Access Compliance Report

Public Rights-of-Way

Intersection ID: 2769	Main Street: ASH_COVE_LN	Cross Street: BEAUVISTA_DR	Location: SW
ADA ID: 50C4DD3B54E0	Ramp Type: BlendTrans1	Initial Pass/Fail: Fail	Overall Compliance: No
			Severity Score: 33.75

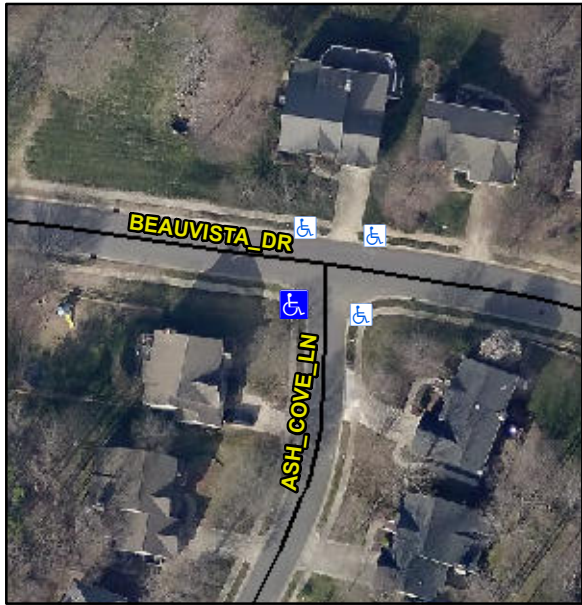
Codes/Mitigation Info/Possible Solution			Field Measurements/Component Compliance					
	Possible Solutions:		Compliance	Description	Data	Compliance	Description	Data
	Remove & Replace Curb Ramp With Two New Directional Ramps or Equivalent.		N/A	Ramp Length (in)	48.0	Yes	BlendTrans Slope (%)	3.3
			No	Ramp Width (in)	42.0	No	BlendTrans XSlope (%)	7.1
			N/A	Flare Type LT	N/A	N/A	Flare Type RT	N/A
			N/A	Flare Slope LT (%)	N/A	N/A	Flare Slope RT (%)	N/A
			N/A	Flare Traversable LT?	N/A	N/A	Flare Traversable RT?	N/A
			N/A	Landing Length (in)	N/A	N/A	DWS Provided?	N/A
			N/A	Landing Width (in)	N/A	N/A	DWS Contrast?	N/A
			N/A	Landing Slope (%)	N/A	N/A	DWS Length (in)	N/A
			N/A	Landing X Slope (%)	N/A	N/A	DWS Full Width?	N/A
Surveyor Notes:		N/A	N/A	Landing Curb? (Y/N)	N/A	N/A	DWS Offset (in)	N/A
			N/A	Shared Landing?	N/A			
PROW/ADA:		R304.5.1, R304.5.3	N/A	Gutter Ponding?	N/A	N/A	Gutter Slope (%)	N/A
			N/A	Gutter Lip Ht (in)	N/A	N/A	Gutter X Slope (%)	N/A

N/A	Painted X Walk1?	No	N/A	Painted X Walk2?	No
				X Walk 1 Direction	To E		X Walk 2 Direction	To N
				X Walk 1 Width (in)	N/A		X Walk 2 Width (in)	N/A
				X Walk 1 Slope (%)	3.6		X Walk 2 Slope (%)	3.3
				X Walk 1 X Slope (%)	2.6		X Walk 2 X Slope (%)	4.8
			N/A	Ramp inside XWalk1?	N/A	N/A	Ramp inside XWalk2?	N/A
				Road Slope (%)	5.4		Clear Space?	N/A
				Road X Slope (%)	4.0	N/A	Clear Space to XWalk (in)	N/A
			N/A	Any Obstructions?	N/A	N/A	Storm Grate/Utility Hazard?	N/A
				Obstruction Type			Storm Grate/Utility Type	
					N/A			N/A
						Yes	Surface Condition? (G/P)	Good
						N/A	Curb Slope (%)	4.4
